# 91–016 Repairing Seat Occupancy Sensor for ISRI, SEARS and National Truck Seats

## TSB-91-016-FTL

### Engine or Vehicle Affected:

Table 2, National Truck Seat Information

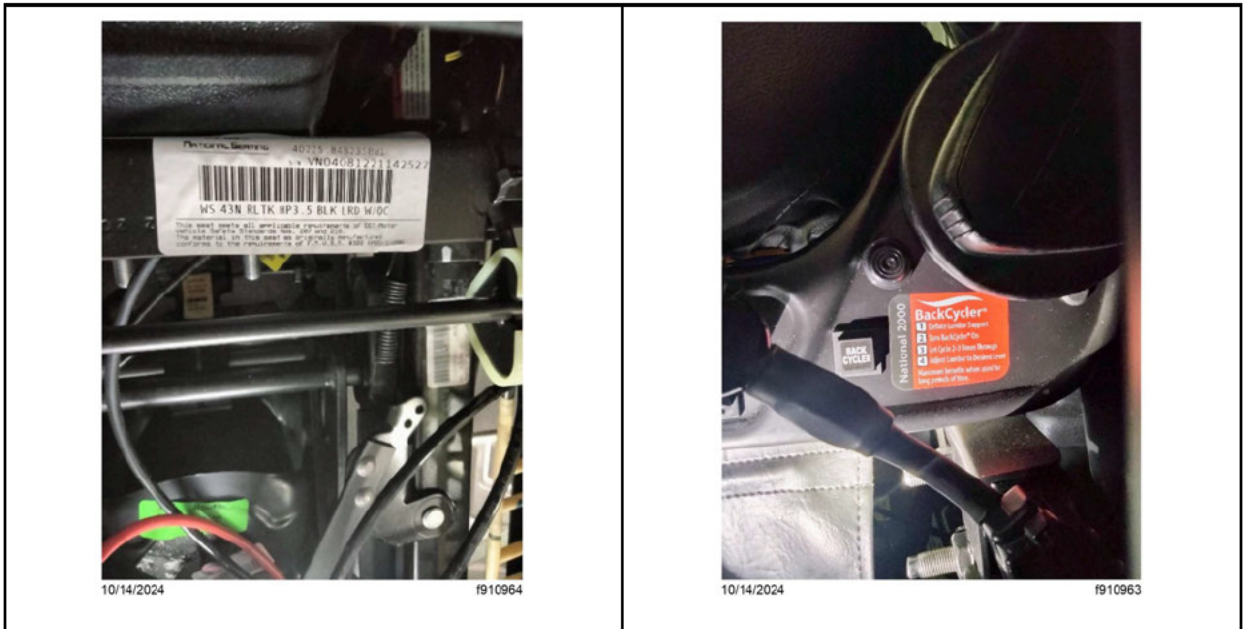
- o For visual ID of National Truck Seat, see figures in Table 2.
